Re: 339 West Gorham Street: Oliv Madison

Attached is a minor amendment packet for the Oliv Madison Project. These changes address some program elements (expanded amenity), design refinements, and adding solar to the project. The packet illustrates the changes between the Original SIP document and the proposed amendments. The site plan review/building permit set elevations are also included for reference to show what was approved with the building permit.

UDC MINOR REVISIONS

ōliv MADISON 339 W GORHAM STREET

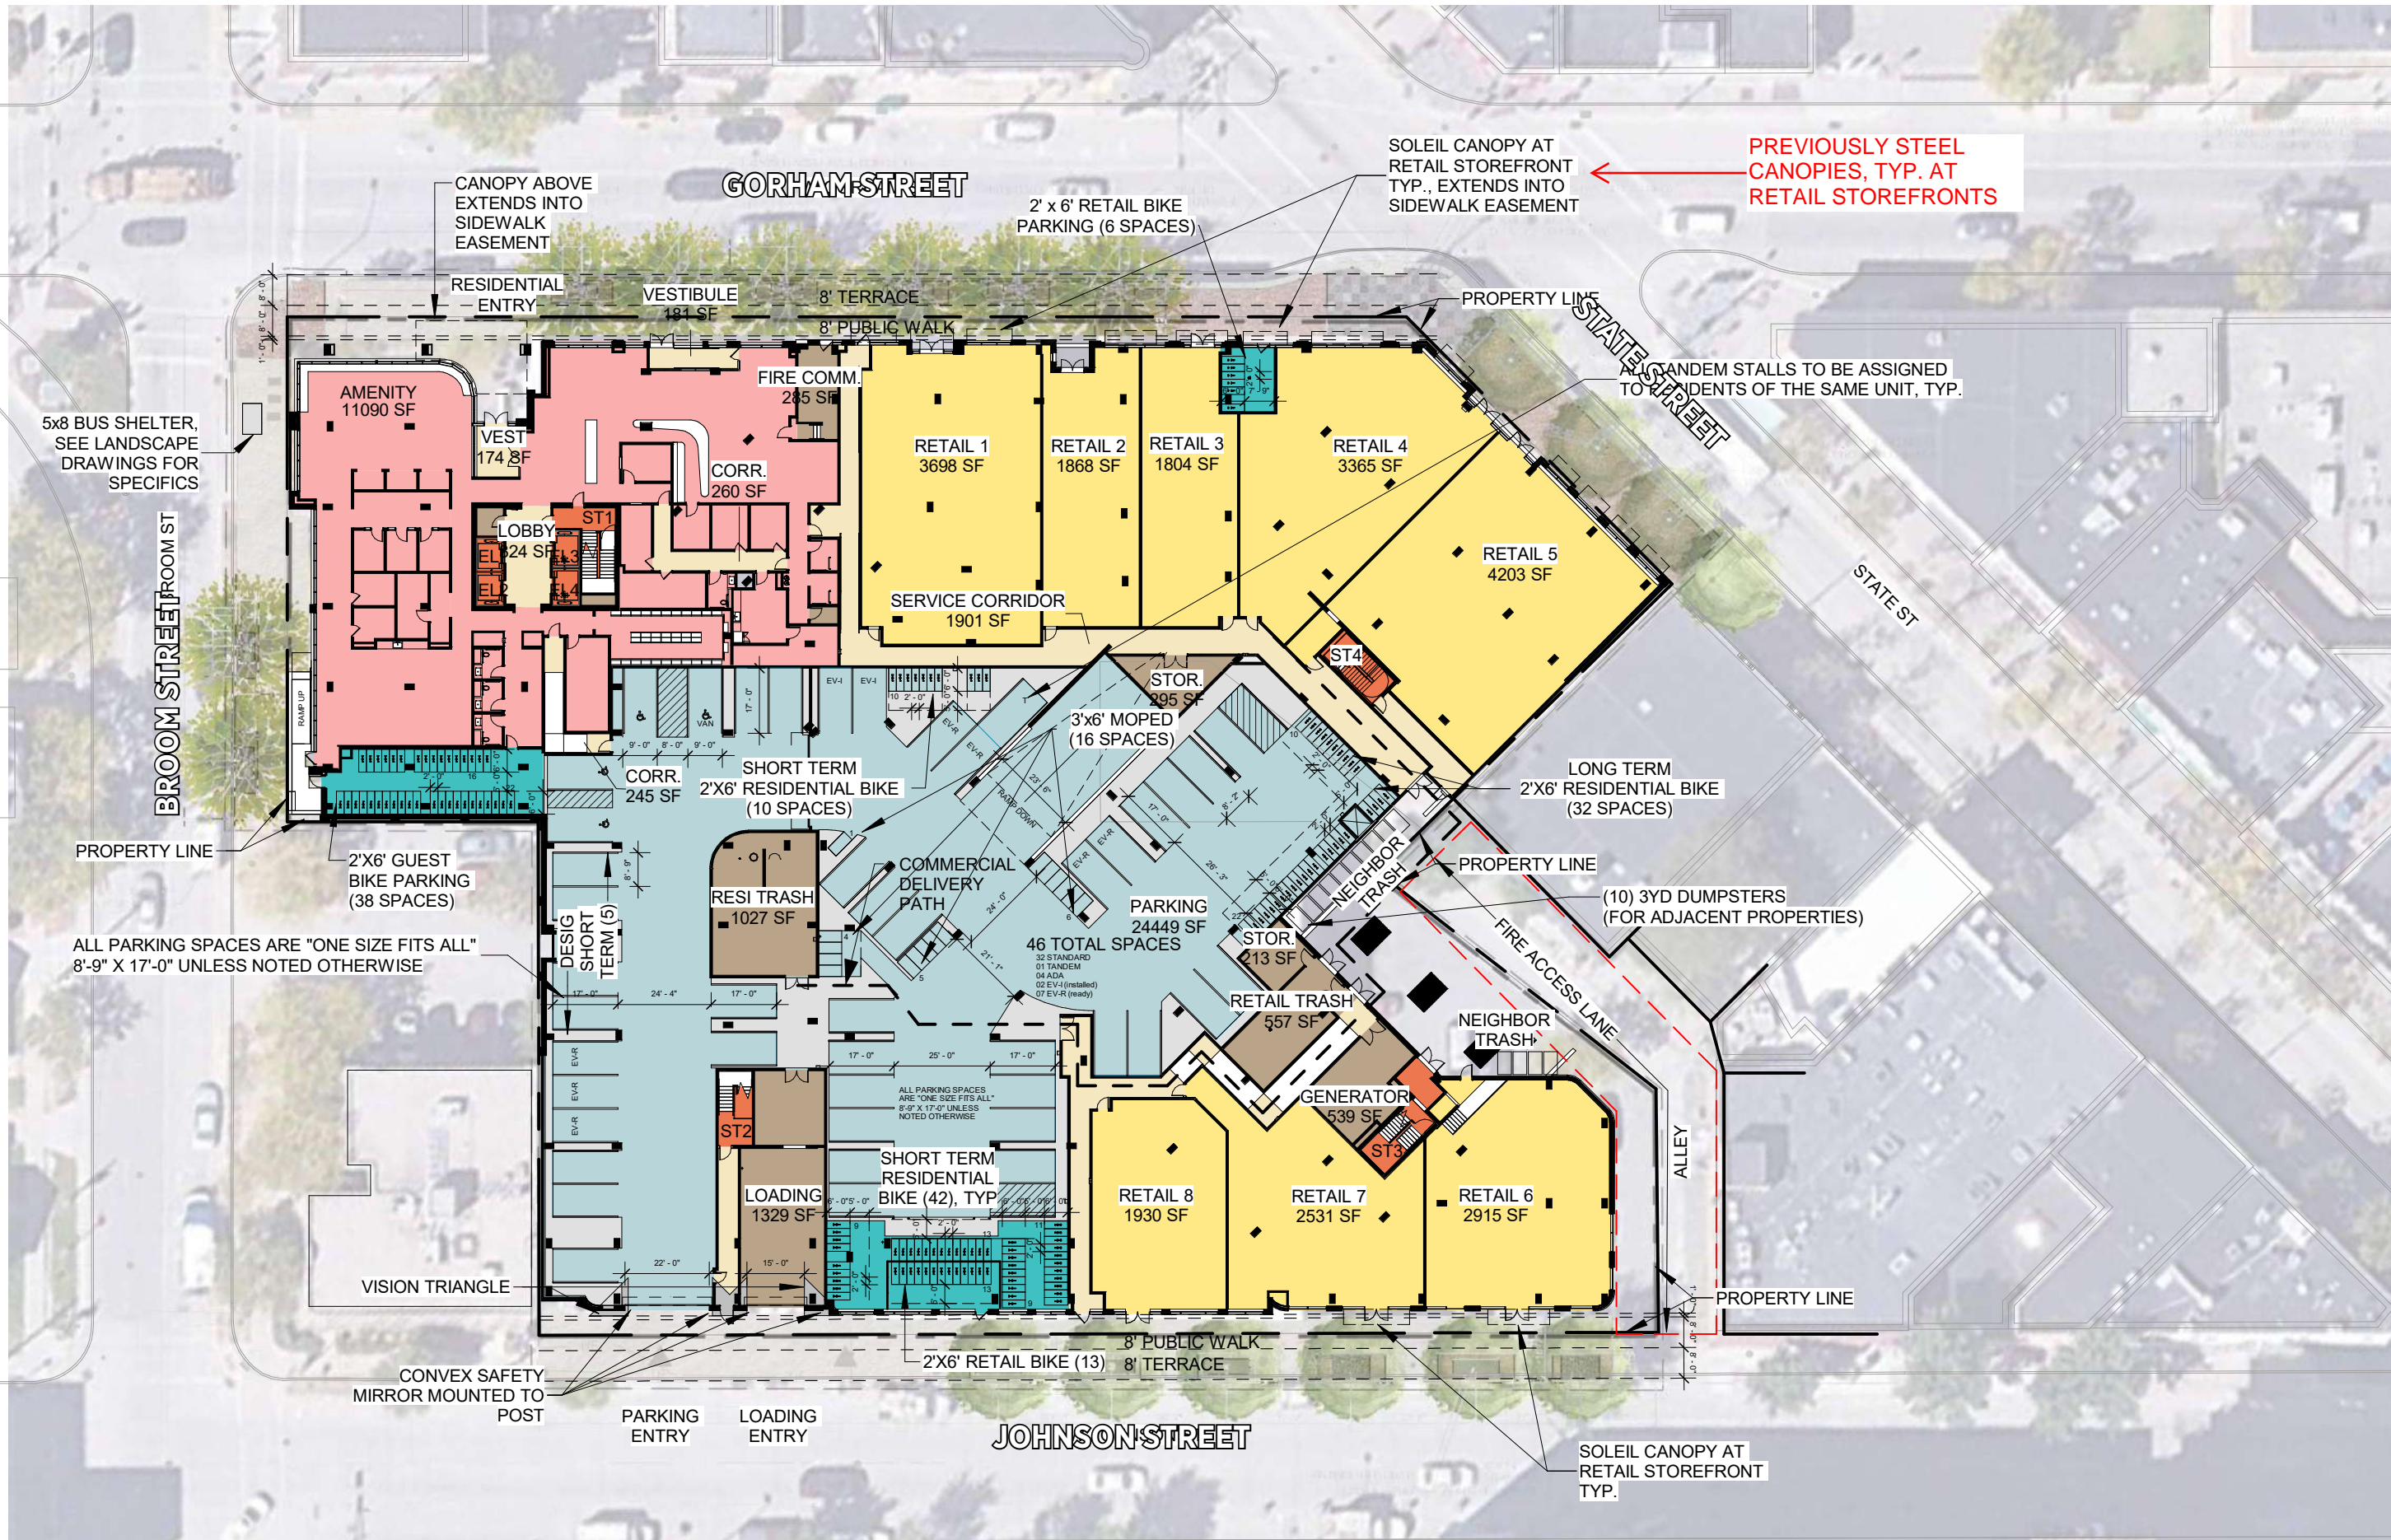
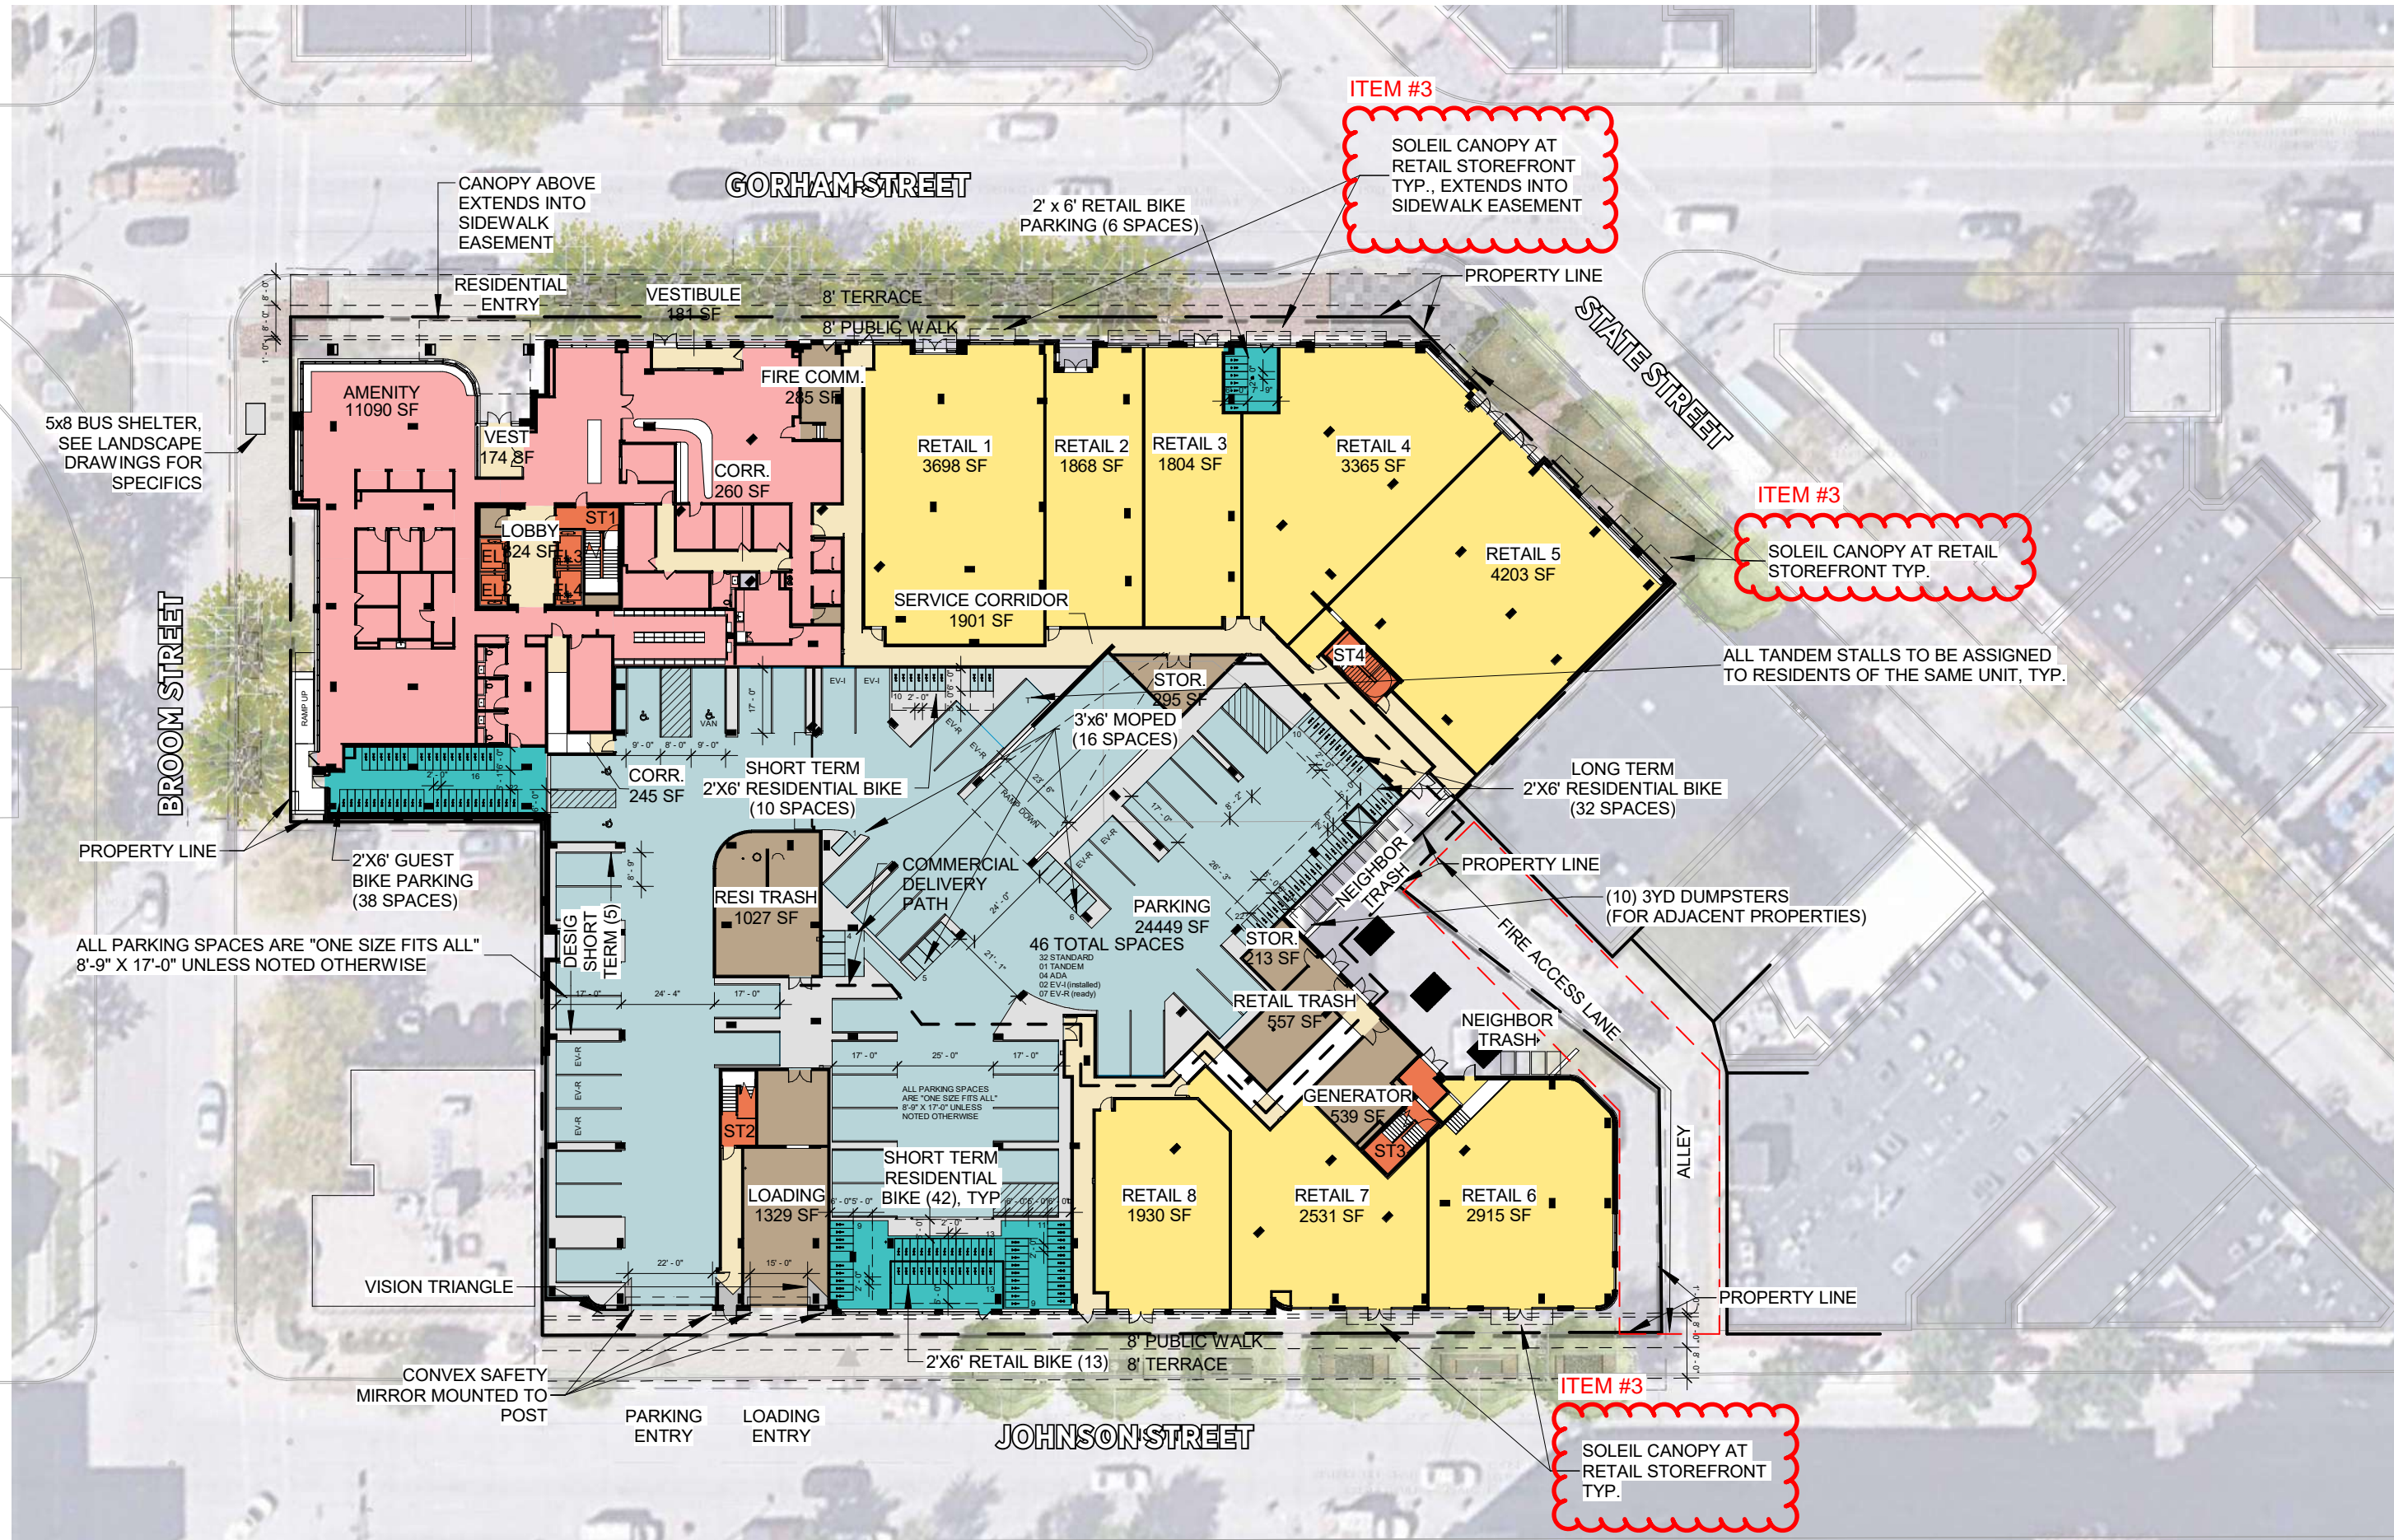
ITEM #28
WINDOW SPACING ADJUSTED TO ALIGN WITH UNIT LAYOUTS - TYPICAL ON ALL FACADES

ITEM #27
GLASS RAILING DEVELOPED FURTHER THROUGHOUT BUILDING - TYPICAL ON ALL FACADES

ITEM #15
SELECT TENANT BALCONY RAILINGS CHANGED FROM GLASS TO PICKET FOR DESIGN PURPOSES

ITEM #29
JOHNSON STREET ALLEY SETBACK

ITEM #13
PARAPETS INCREASED IN HEIGHT TO ACCOMMODATE REQUIRED ROOF ASSEMBLY

ITEM #16
JOHNSON FACADE CORNER WINDOW

ITEM #23
LOUVER REQUIRED PER MECHANICAL DRAWINGS.

ITEM #4
RESIDENTIAL GARAGE DOOR HEIGHT REDUCED - BRICK DETAILING ADDED. GARAGE DOOR LITES REVISED PER DOOR MANUFACTURER STANDARDS

ITEM #18
EGRESS DOOR

ITEM #25
CURVED GLASS REPLACED WITH CURVED METAL PANEL TO CONCEAL COLUMN.

ITEM #3
PROPOSING ALUMINUM LOUVERED CANOPIES AT RETAIL STOREFRONTS.

ITEM #24
HISTORIC FACADE UPDATED PER DESIGN DEVELOPMENT AND LASER SCAN
